In the Drawings

Remarks

FIG. 7

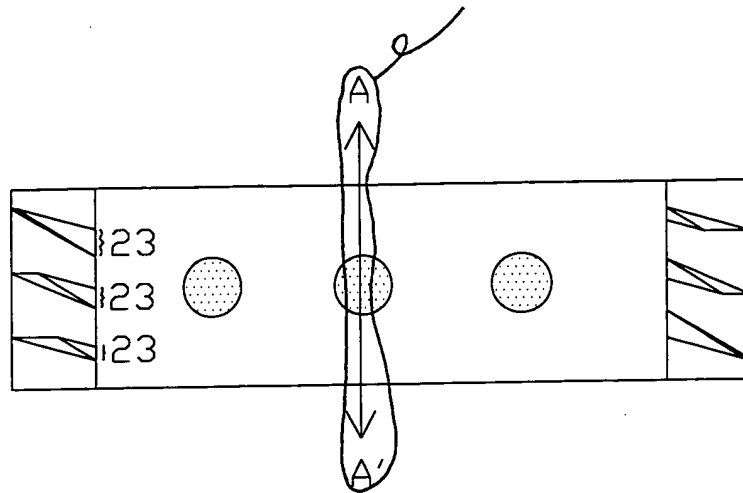
Figure 7 has been amended to delete reference to “longitudinal plane A-A’ ” since it is no longer referred to in the specification, or the claims pursuant to the Examiner’s request and the amendments herein.

FIG. 8

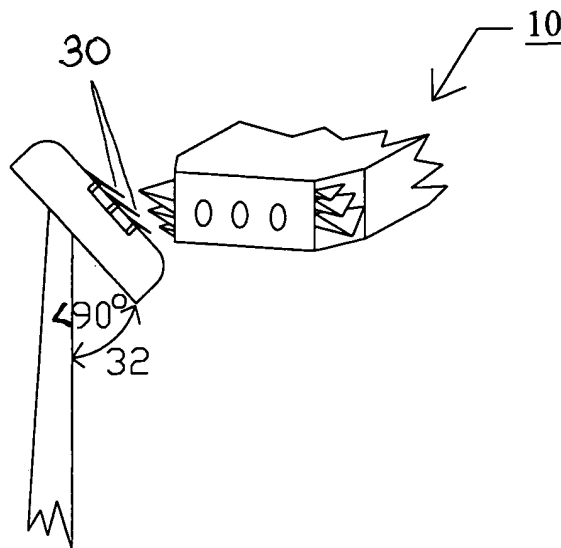
Figure 8 has been amended to include reference numeral **30**, as requested by the Examiner and described in the specification. In addition, the symbol “<” has been inserted before “90°” to clarify that the angle shown is less than 90°.

The drawings have been objected to for failing to comply with 37 CFR §1.84 because reference number "30", as described in the application was not indicated in the figures. As described above, a new drawing page 4 has been attached herewith, along with an annotated sheet showing edits. The new drawing page includes reference number "30". In addition, to coincide with the amendments that will be discussed below, reference to longitudinal plane "A-A" has also been removed from Figure 7. And, as a matter of clarification, a "<" symbol has been inserted in Figure 7 to clarify that the indicated angle is obviously less than 90°. Support for this amendment can be found at page 8, line 16. Applicant respectfully asserts that these amendments do not constitute new matter and respectfully request that the new drawing sheet be included in the application.
